RIDE THE DUCKS INTERNATIONAL

Bulletin No. SB-00-07-13

SERVICE BULLETIN

Emergency Curtain Release System

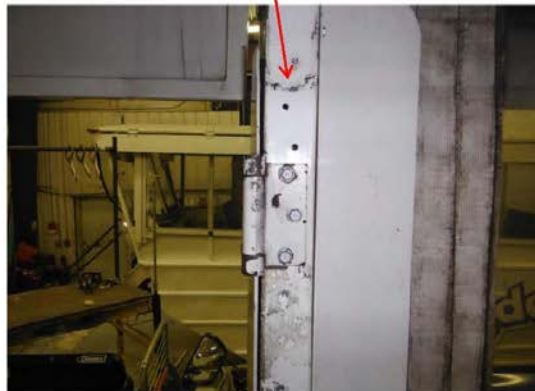
Holes showing where the hinges were previously located.

With the vertical curtain guides and hinges located in the upper position, the vertical curtain guides hit the upper sign preventing them from opening.

Curtain release hinges had to be moved back down to the original location.

PROPER INSTALLATION OF SIDE MARKER LIGHTS

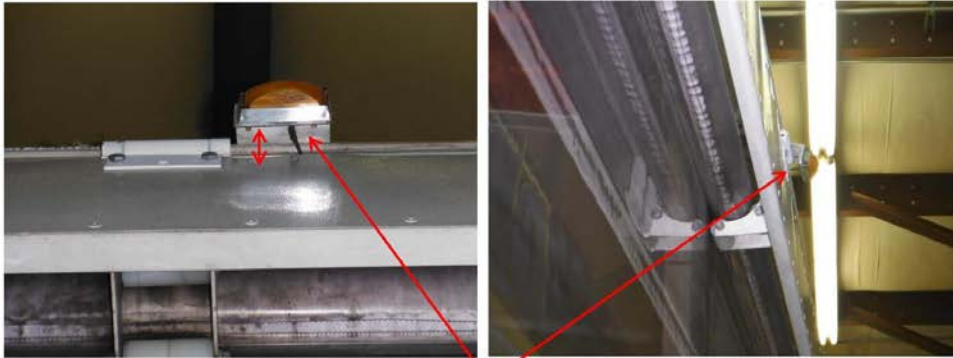
Marker lights must be set out away from upper sign, allowing the signs to fully open during curtain release deployment.

Later model Ducks have flush mounted marker lights and are also approved
